Randwick Local Planning Panel (Electronic) Meeting

Thursday 22 August 2024

Development Application Report No. D67/24

Subject: 5 Mermaid Avenue, Maroubra (DA/209/2024)

Figure 9: Extract of rear elevation prepared by Alec Pappas Architects. Location of proposed kitchen has been indicated in red outline, while location of walk-in-robe addition has been shown in green outline.

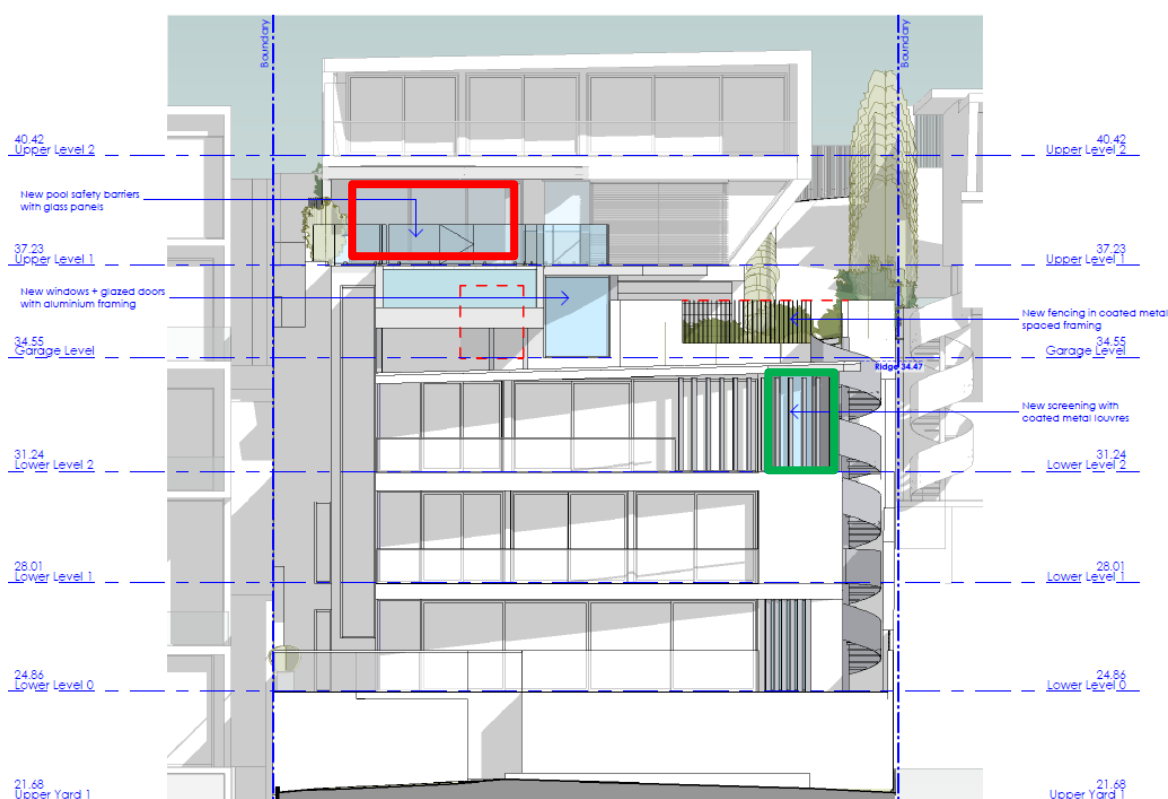
While an increase in GFA occurs, the additional GFA generally relates to the enclosure of existing external areas. At No.5 Mermaid Avenue, the only additional GFA sought relates to the extension to the existing kitchen through the shifting of the sliding glass door, resulting in the enclosure of the area identified in Figure 8 below. The enclosure of this space, does not result in any changes to the overall building bulk and form as evident in elevation plan shown in Figure 9.

Figure 11: Extract of existing and proposed lower level 2 floor plan prepared by Alec Pappas Architects.

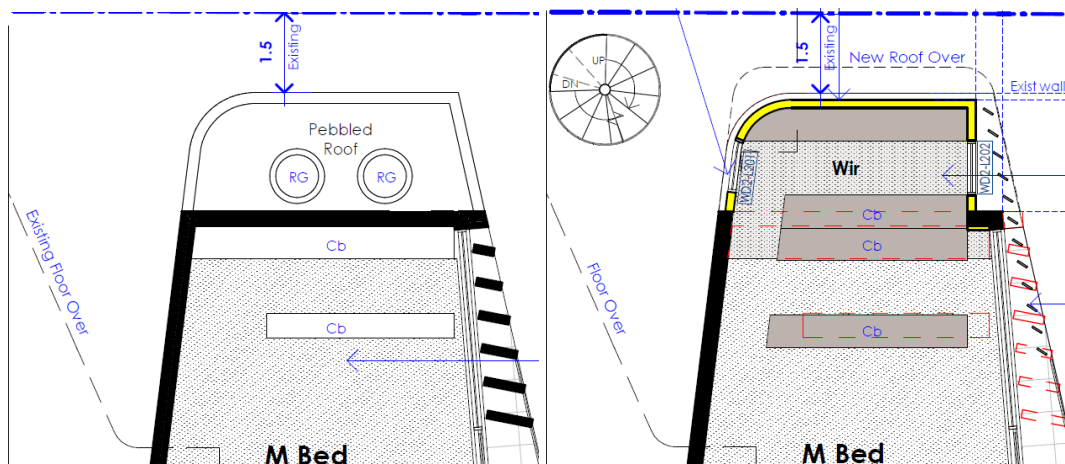
In terms of the walk-in-robe addition to the Master bedroom, the area of the addition is limited to the existing envelope of the pebbled roof, as evident in Figure 11 below. As such, the addition of the walk-in-robe does not further encroach on the existing setbacks of the built form and will seamlessly integrate within the existing envelope of the building, as evident in the rear elevation plan previously shown in Figure 9.

Figure 14: View lines from No.3 Mermaid Avenue, Maroubra, extracted from Statement of Environmental Effects prepared by Damian O'Toole Town Planning and Heritage Services.

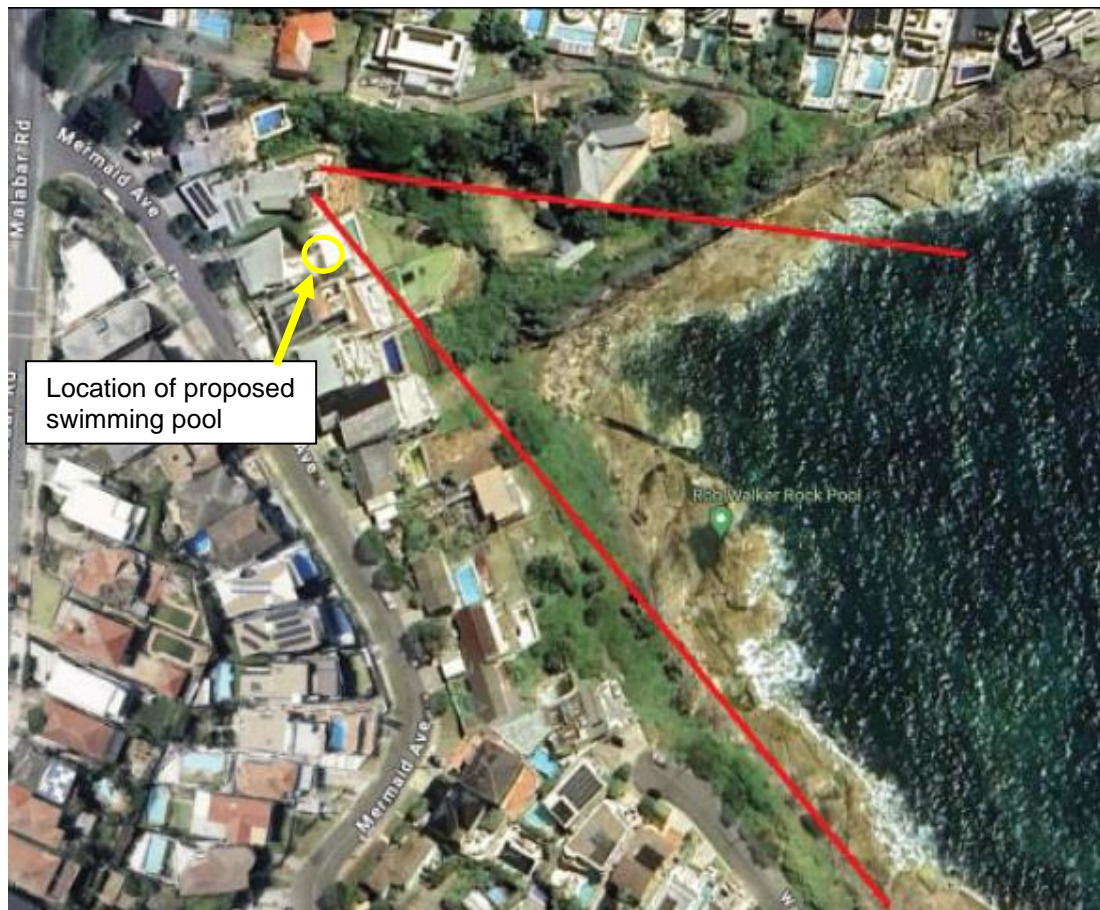
The proposed swimming pool does not exceed the existing height of the upper level terrace floor level. The variation proposed is largely as a result of previous excavation works which have lowered the ground level directly under the location of the swimming pool. It is also important to note that the subject site and adjoining sites all slope significantly downwards from street level to the rear boundary, resulting in larger built forms towards the centre and rear of each respective site. Therefore, while the swimming pool is situated above the maximum building height of 9.5m, it remains 1.5m below the existing ground level of the site at street level.

Figure 16: View of existing raised terraces of adjoining properties from the existing upper level terrace of No.5 Mermaid Avenue.

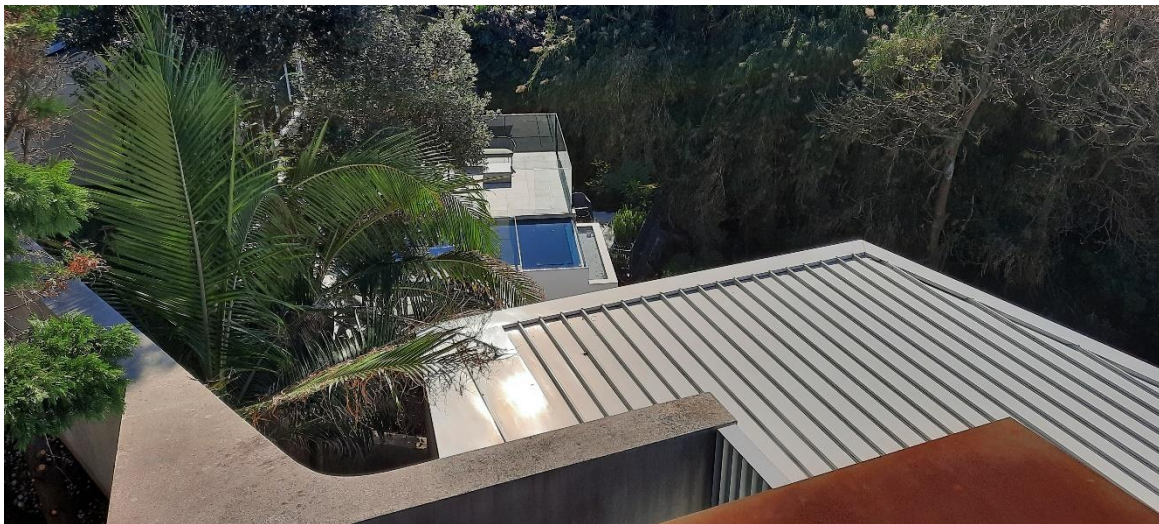
While the proposal seeks to relocate the swimming pool to the edge of the existing terrace, the trafficable area of the terrace remains relatively unchanged. The additional area that is proposed beyond the edge of the existing terrace is limited to the proposed swimming pool area, with the pool fence and gate situated further back from the edge of the existing terrace. The proposed location of the swimming pool is not uncommon for the area noting that No. 3 Mermaid Avenue also provides a swimming pool located at the edge of a raised terrace area (as can be seen in Figure 16).

Figure 9: Extract of proposed ground floor plan (Source: D-Studio Architects)

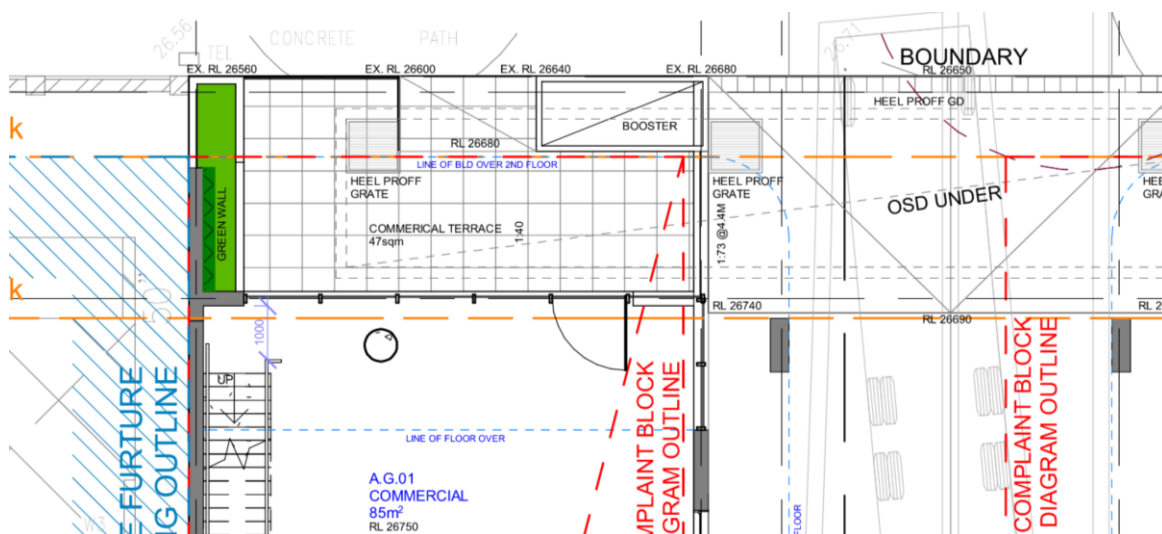
The proposed development includes a commercial tenancy at ground floor level of Building A. However, Council is not satisfied that the Bowral Street frontage is suitably activated. As shown in Figure 9 below, the street frontage is obstructed by a large booster structure. The commercial tenancy is recessed by 4m from the street, and it is unclear how the proposed 'commercial terrace' will activate the Bowral Street frontage.

Council is not satisfied that the proposal achieves the objective of clause 6.20, which seeks to promote uses that attract pedestrian traffic along ground floor street frontages. Importantly, the proposal does not include an awning to the Bowral Street frontage, as required by Part 18 of the K2K DCP.

Figure 10: Proposed height plane diagram (Source: D-Studio Architects)

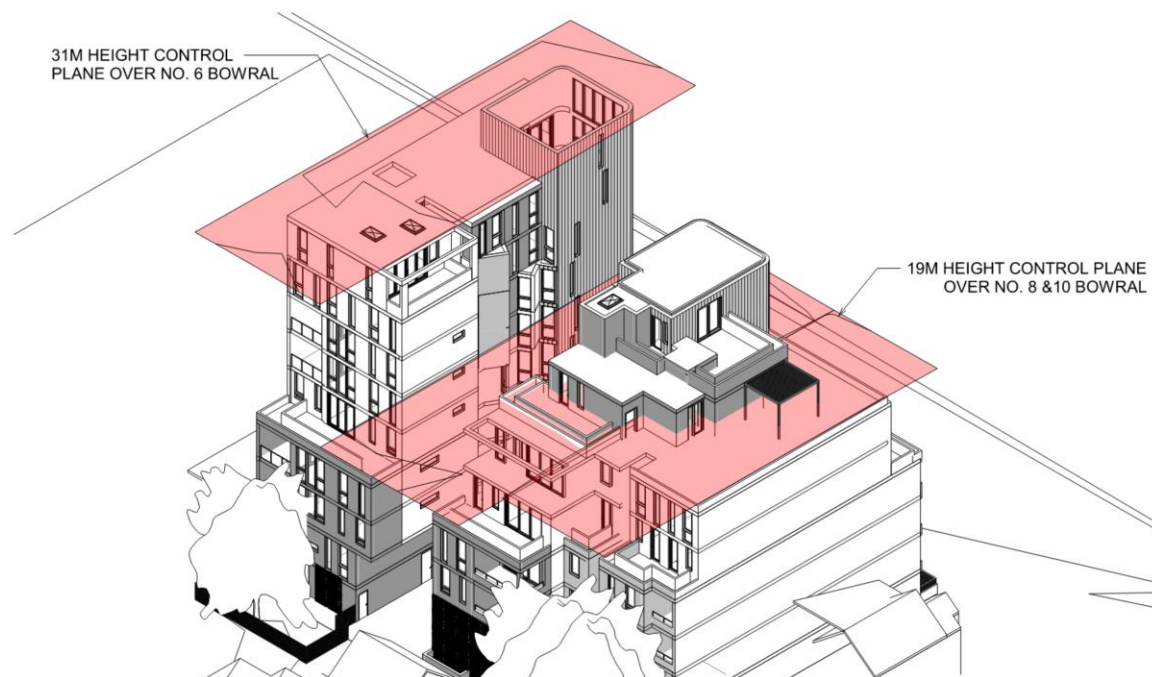
Clause	Development Standard	Proposal	Proposed variation	Proposed variation (%)
Cl 4.3: Building height (max) and Cl. 6.17 Community infrastructure height of buildings and floor space at Kensington and Kingsford town centres	31m (No. 6) – Clause 6.17 19m (Nos. 8-10) – Clause 4.3	31m (No. 6) 24.88m (Nos. 8-10)	5.88m (Nos. 8-10)	30.9%

Figures 3 to 8 provide a comparison of the approved and proposed modified development.

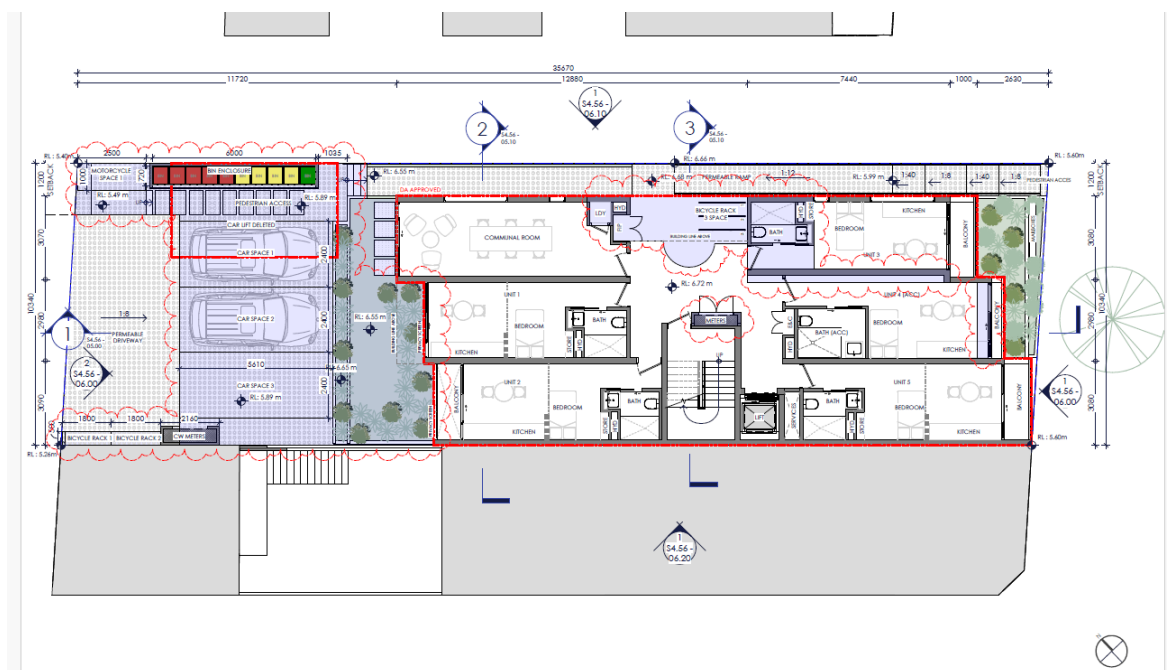
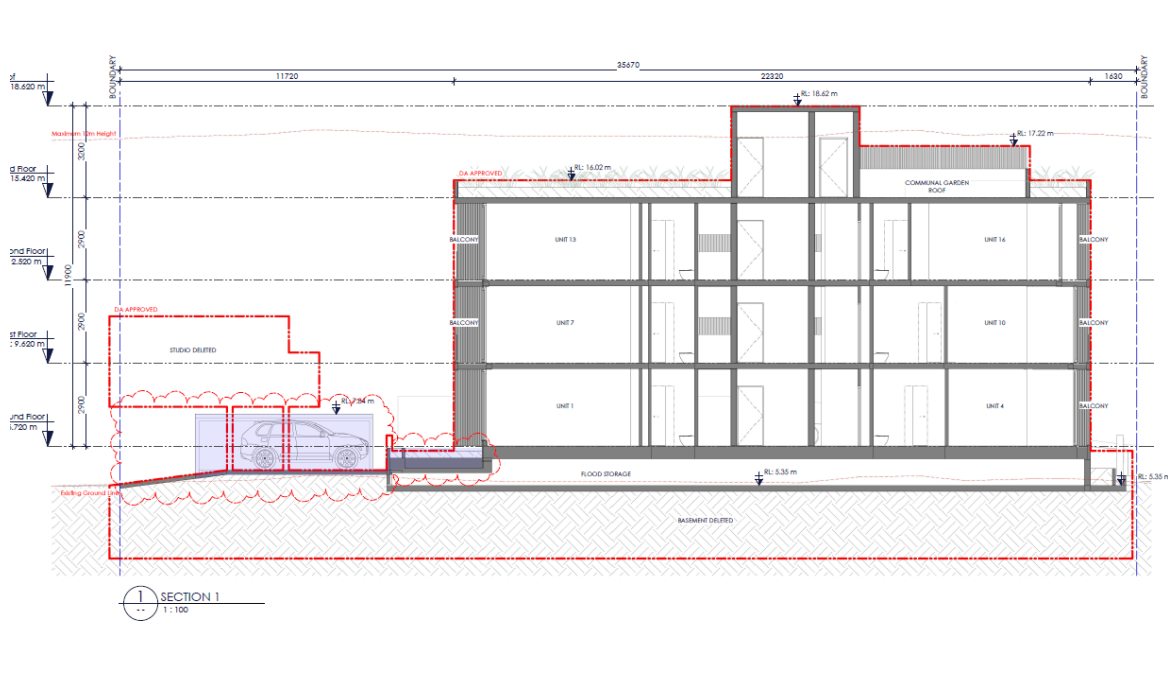
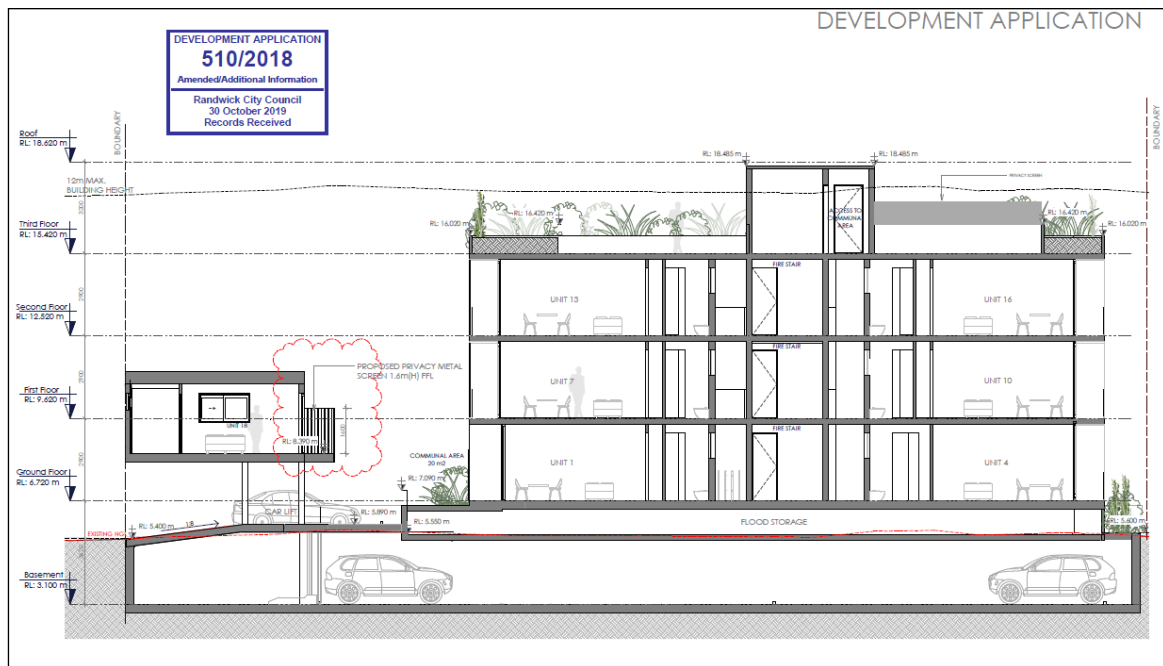
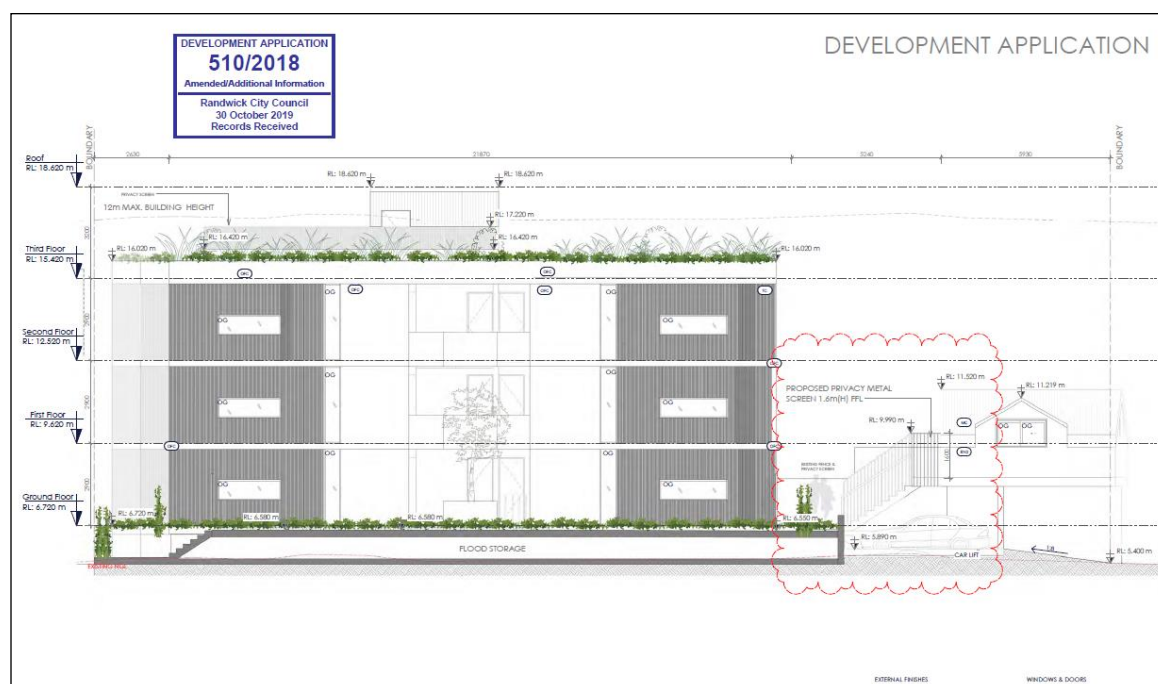
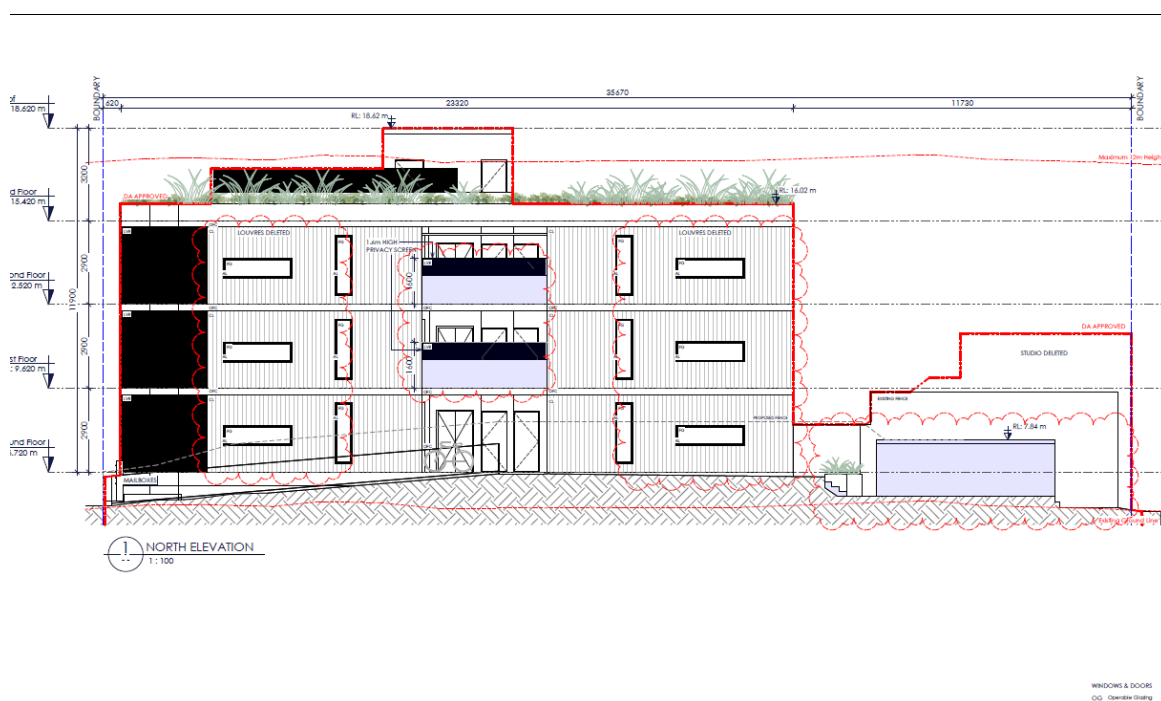
On 16 July 2024, Council received updated plans showing the at-grade car spaces at RL5.89 AHD in accordance with the flood requirements. This assessment is based on the amended plans received 16 July 2024.
